PLANNING AND ZONING MINUTES:

February 14, 2017

Chattanooga Form-Based Code

Proposed 6-Month Edits

Hotel Drop-Offs

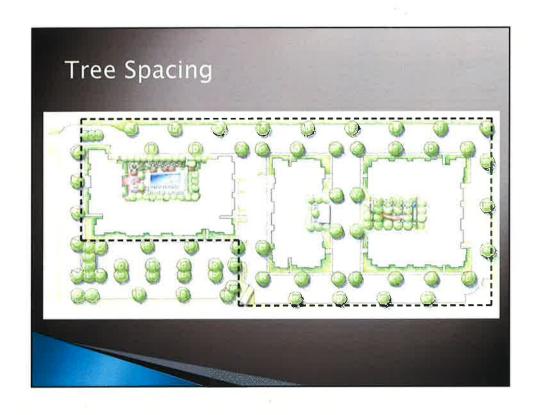
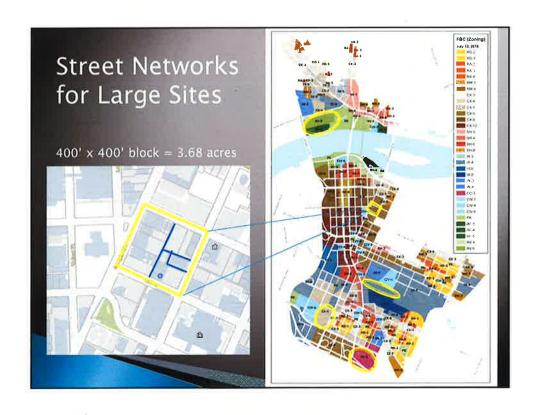
Option 1: Rear drop-off

Hotel drop-offs must occur to the rear of the building where either of the following conditions occur or are to be built:

- a. An alley or a rear driveway entering from the secondary street
- b. In the absence of a secondary street a primary street may be used to access the rear of the lot provided lot frontage requirements are met.

Option 2: Side drop-off

Hotel drop-offs may occur to the side if a physical hardship can be clearly demonstrated. Hardships must not be self-created or financial. See Sec. 38-696(4)C.4.a.)

For lots with a width less than 100 feet a Minor Modification may be requested to reduce the lot frontage requirement.

Option 3: On-street drop-off

Hotel drop-offs may only occur along the public street where on-street parking is provided and with the approval of CDOT and the Chattanooga Parking Authority. On-street parking may be constructed by the developer provided it is the full length of the block or a minimum of 400 feet long. Right-of-way must be dedicated to the City for maintenance of on-street parking facilities.

The number of on-street spaces allowed will be based on the number of hotel rooms. Requirements for the Sidewalk and the Street Tree / Furniture Zone must be met where on-street parking is added.
